ANN ARBOR HISTORIC DISTRICT COMMISSION

Staff Report

ADDRESS: 225 South State: Condo 2, Application Number HDC 16-126

REPORT DATE: July 14, 2016

Proposed Roof Plan

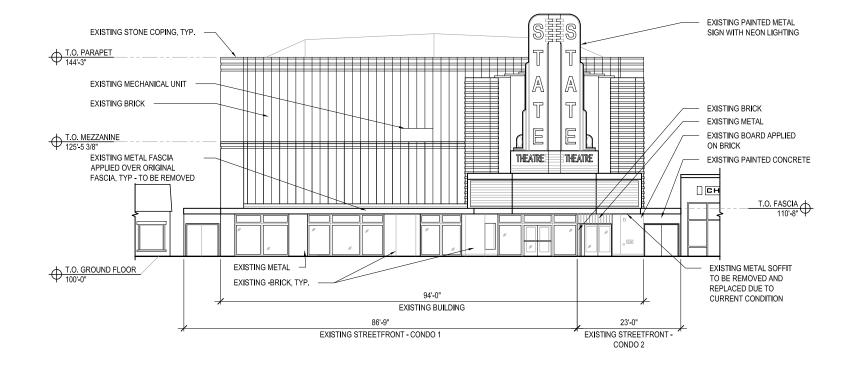
- 3. Other alterations. Rooftop mechanical units are proposed on the roof, out of sight. One redundant emergency egress door is proposed to be infilled on the north elevation using salvaged brick.
- 4. Given the complexity of adding an elevator to a building with a ground floor in separate ownership, and designing it for an architecturally unique building, staff believes that the proposal is appropriate and complimentary. It meets *The Secretary of the Interior's Standards for Rehabilitation* and *Guidelines for Rehabilitating Historic Buildings*, and the *Ann Arbor Historic District Design Guidelines*.

Proposed West Elevation

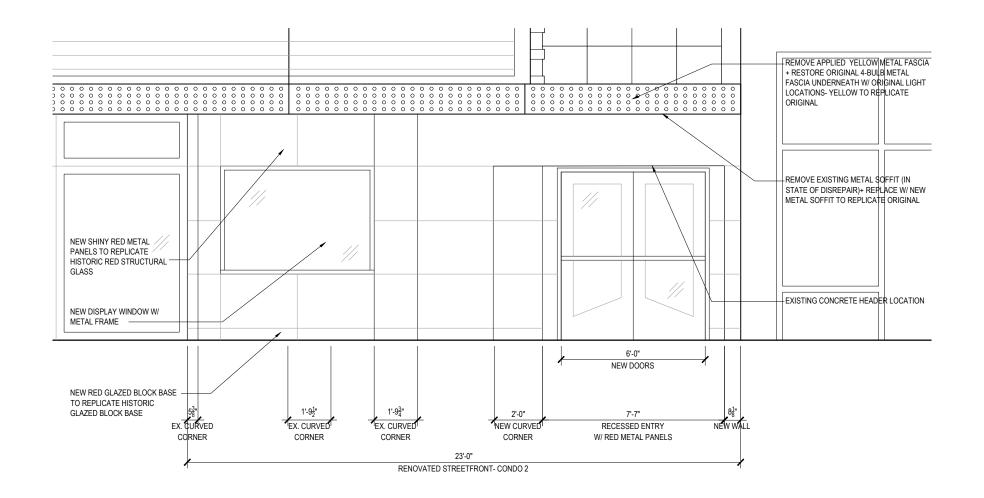
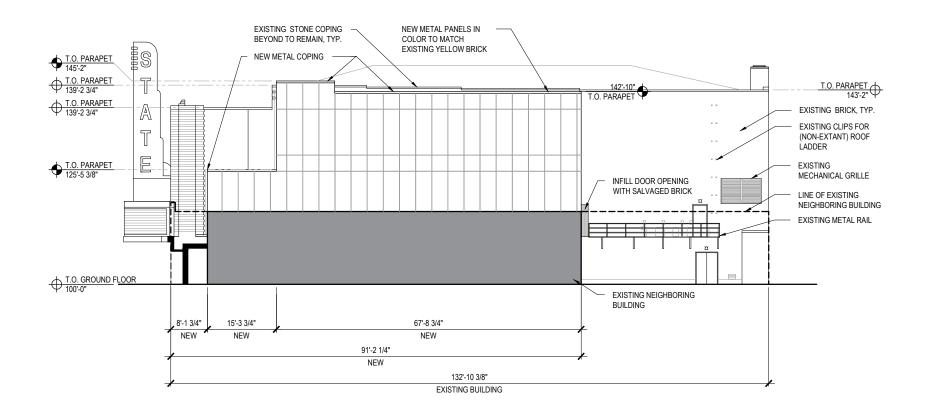
- Façade restoration. The yellow metal fascia that spans the front of the building will be removed to reveal and restore the original lightbulb locations. The metal soffit beneath the marquee will be replaced with matching materials and dimensions because of deterioration. The sign will be repainted and new neon installed as needed.

Proposed South Elevation

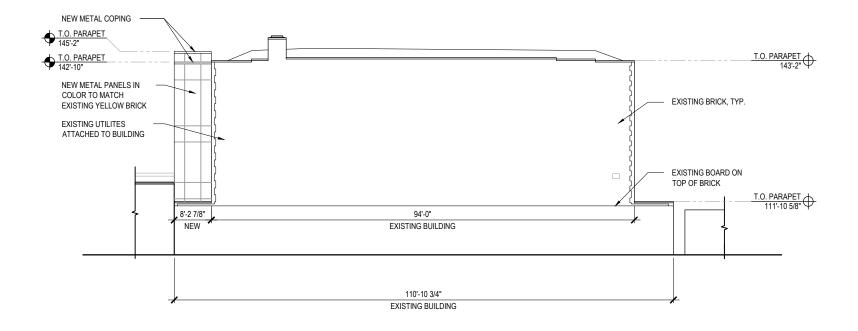
- 2. *Elevator Addition*. A new three-story elevator with a 700 square foot footprint (8'3" x 91'2") is proposed along the south side of the building. The elevator will be used to access both the mezzanine level, for concessions and restrooms, and the theatre level, which will be converted from two screening rooms to four. The elevator will require the removal of a pair of original steel windows on the south elevation, and a non-original grille on the third floor, a door at grade, and another on the second floor. A new main entry with shiny red metal panels will be located at the south end of the theatre's front elevation, with double doors and a display window. The second floor of the elevator enclosure will face the street with clear glass, and the third floor will have dark-colored glass. The south-facing elevation will be clad in metal panels to match

the existing yellow brick.

The applicants have been very careful to keep the elevator enclosure clear of all character-defining features of the building. The stepped design helps it to recede, and attention to details (like the art-deco style sawtoothed windows that mimic the front of the building) tie it to the building cleanly and gracefully.
